# **EPA Superfund Record of Decision:**

**Hanford 200 Area (USDOE),  
(200-UP-1 Operable Unit)  
Benton County, WA  
2/11/1997**

## DECLARATION OF THE RECORD OF DECISION

Figure 2. Location of 200-UP-1 Groundwater Operable Unit.

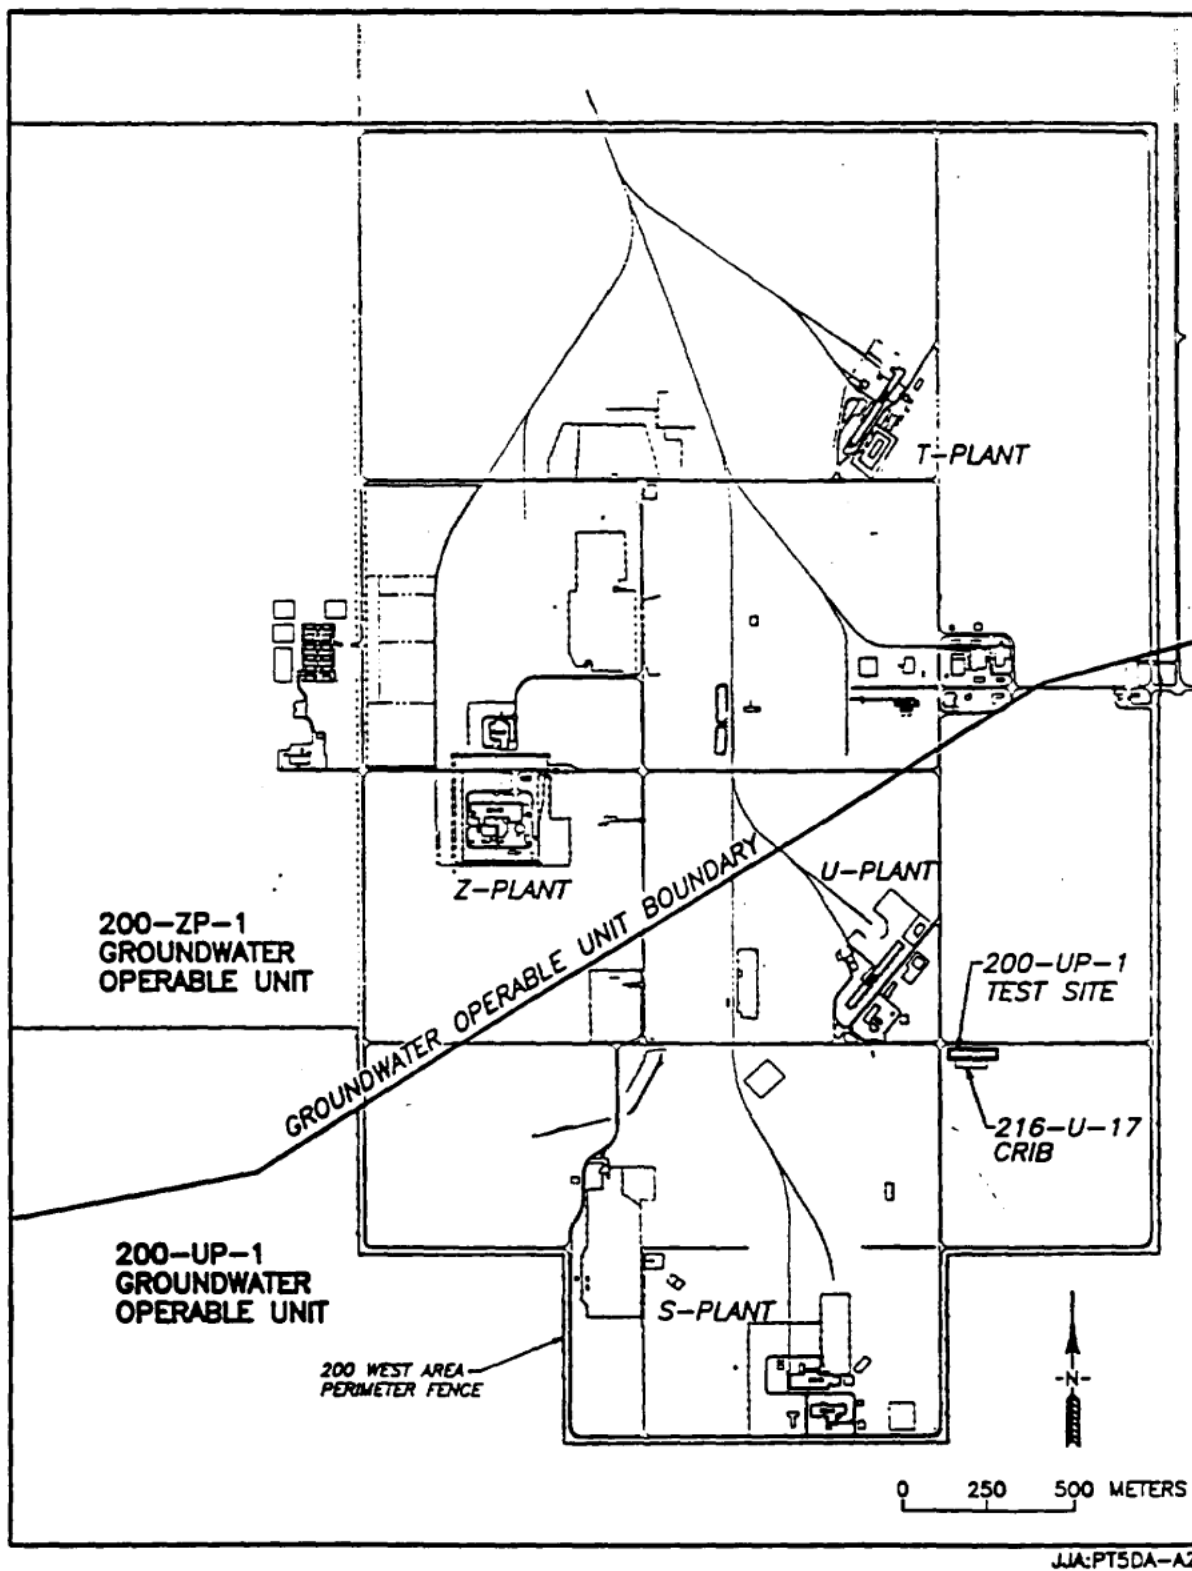
**Page 3, Figure 2**

Figure 2 has an unacceptable lack of detail. All groundwater monitoring wells should be shown along with measurements of the contaminants. Additional figures should be shown to map each of the plumes individually. The carbon tetrachloride plume is not shown on Figure 2.

The maximum concentrations for each of the contaminants are not specifically shown on Figure 2.
